Application for Licence Amendment

Licence Number	L7337/1998/10
Licence Holder	Alinta Energy Transmission (Roy Hill) Pty Ltd
ACN	159 279 857
File Number	DER2013/001074
Premises	Newman Power Station Newman WA 6753 Legal description – Lot 555 on Deposited Plan 400578
Date of Report	7 August 2020
Proposed Decision	Intent to grant revised licence

Figure 2: Ratio of measured NO_x and NO₂ at South Hedland

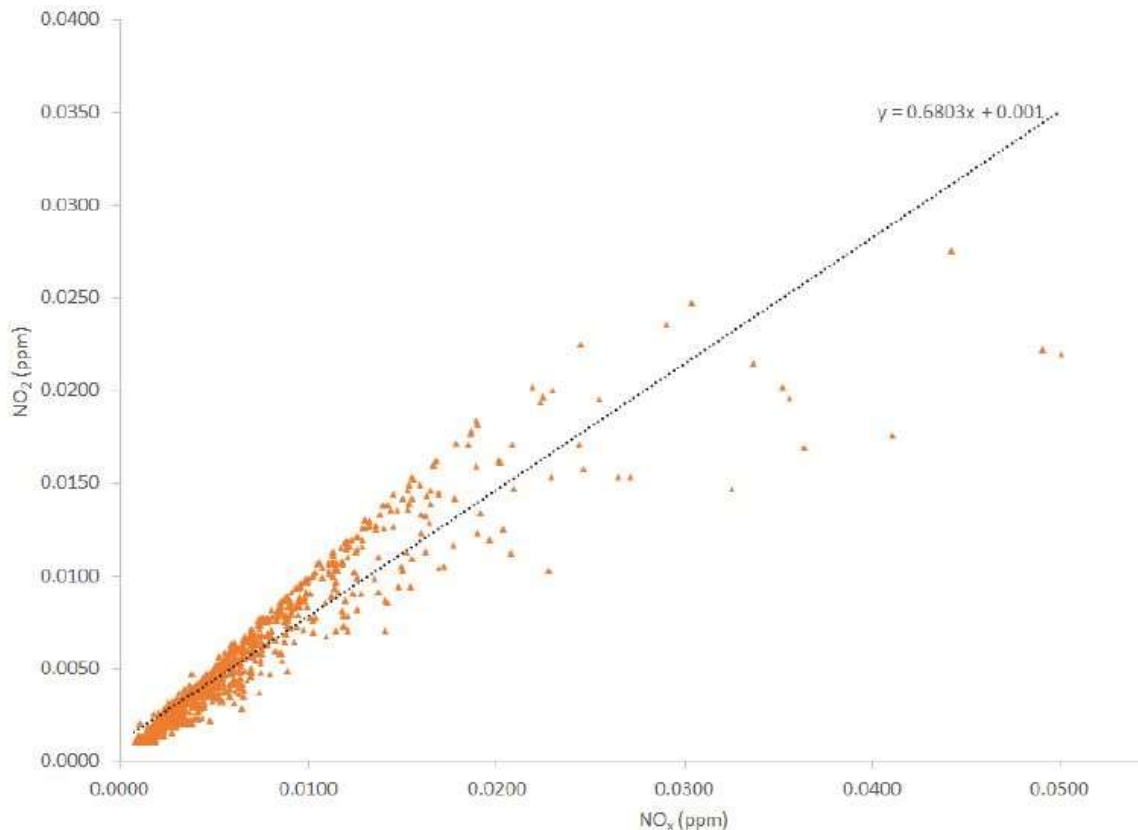
The Delegated Officer has observed that there is a significant degree of scatter in the measurement points presented in Figure 2 above NO_x levels of 0.03ppm, such that a linear relationship is in doubt. It is also apparent that for the third highest measured level of NO_x the 0.439 ratio provides a significant underestimation of the corresponding NO₂ level.

The Delegated Officer sought advice on this matter from the Department’s Air Quality Branch (AQB). The advice received was that the conversion ratio applied to this assessment, and also a similar assessment of the adjacent Yarnima Power Station, is not conservative, and could be leading to underestimations of ground level concentrations of NO₂.

The Delegate Officer has concluded that the Licence Holder’s chosen conversion ratios introduce significant uncertainty to the predicted ground level NO₂ concentrations.

The to address the uncertainties associated with the lack of location specific data to determine a NO_x:NO₂ ratio (see Section 3.1.3), the Delegated Officer considers a form of emissions monitoring which is capable of capturing worst case emissions from the premises is required to supplement the existing annual stack testing, which only provides a snapshot of emissions. Therefore, a condition has been added to the revised licence to require a Predictive Emission

Monitoring System (PEMS) to be operated across all generators on the Premises.

Figure 3: Modelled sensitive receptor vs receptor location in the modelling report (ETA 2020)

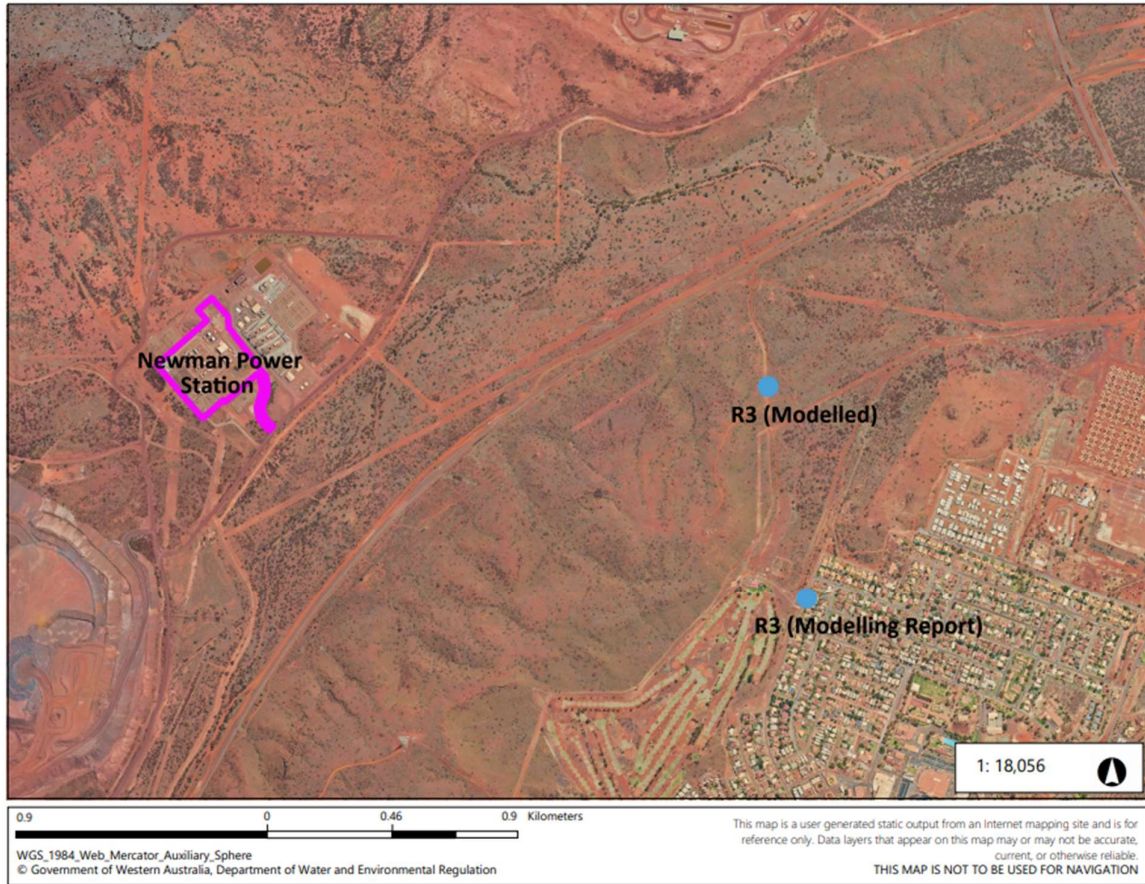
The Licence Holder’s modelled GLCs, for each scenario, at the nearest residential receptor, are summarised in Table 5; the relevant NEPM standard is in brackets. The Delegated Officer has observed that the coordinates for the receptor R3 (the nearest residential receptor) in the Calpuff modelling input file provided by the Licence Holder to support the modelling results

does not correspond to the location of the nearest residential receptor provided in the modelling report (ETA 2020) (Figure 3). The Delegated Officer has thus concluded that there is significant uncertainty as to whether the predicted NO₂ concentrations are representative of GLCs at the nearest residential receptor.
